Mitsubishi Electric Corporation Industrial-Collaborative Robot

MELFA Technical News

BFP-A6079-0351E

Subject: Notice of Change in Appearance, etc. of Robot Controller (CR800)

<Before : CR800 Rear View>

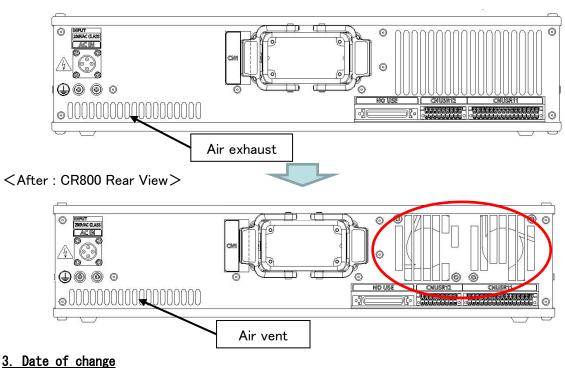
The cooling fan inside the controller will be changed from the front side of the controller to the rear side. The shape of the slit on the back of the controller will be changed as shown in the figure below. In addition, screws for fixing the fan will be added to the back of the controller. There are no changes from the specifications of controller listed in Standard Specifications Manual 3. 1. 1 Basic Specifications as a result of this change. The term "Air exhaust" in 3. 2 Names of each part (Fig. 3-1) of the Standard Specifications Manual will be changed to "Air vent".
